Informal document **GRE-83-49**  
83<sup>rd</sup> GRE, 19-23 October 2020  
agenda items 4.(c) and 6.(a)

# **Possible concerns on the document ECE/TRANS/WP.29/GRE/2020/4**

# Survey Report on Driver Assistance Projection

Fig.1 Excerpts from the presentation (SLR-38-17/Rev.1)

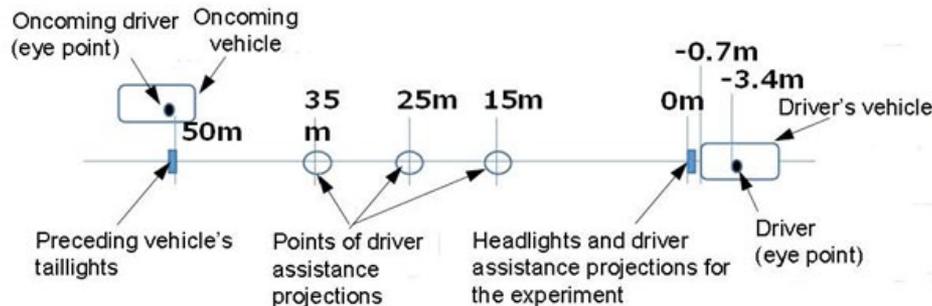
The survey indicated that **projections caused a delay of 0.1 to 0.2 seconds in the drivers' brake reaction time**. Further, the presentation generated many comments from CPs that more detailed studies were necessary. The most notable comments were as follows:

1. The presentation shows a delay in brake reaction time caused by driver assistant projections, but isn't it still unclear what the safety implications are of road surface reflections, optimal projection distance, weather effects, optimal brightness/luminosity, etc.?
2. This is the result of a static experiment. Wouldn't we get different result if we evaluated a dynamic experiment?
3. Is there a risk from reflective glare on wet road surfaces?

The above comments suggest that **there are still many issues** to be clarified in ECE/TRANS/WP.29/GRE/2020/4. We need to continue discussion more in detail.

Fig.2 Reflective glare of headlights on a wet road

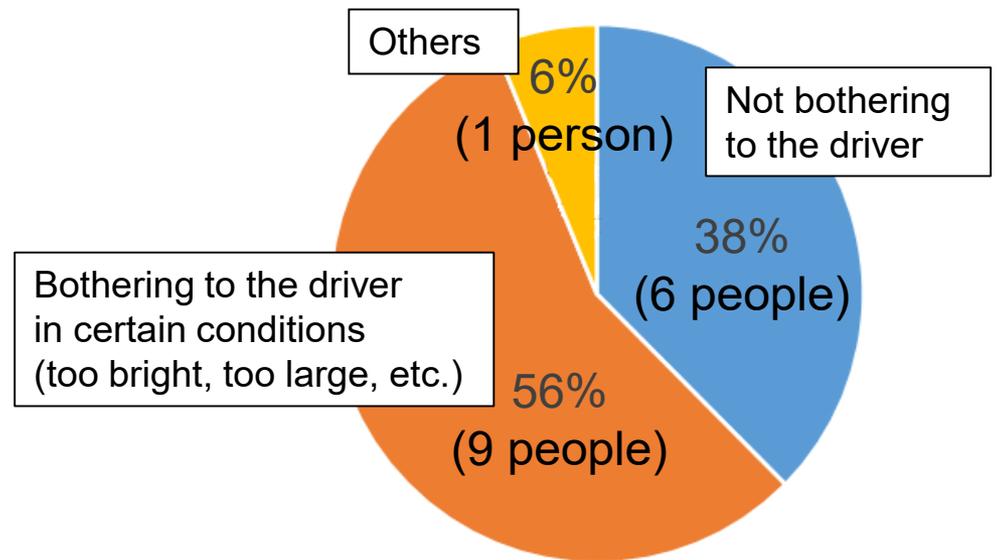
1. Disability glare to oncoming traffic on wet road surfaces
2. Range of symbol types
3. Banning flashing or transforming symbols
4. Restriction on symbol colors
5. Limitation of the illumination range
6. Duration of symbol projection
7. Impact on oncoming traffic and pedestrians
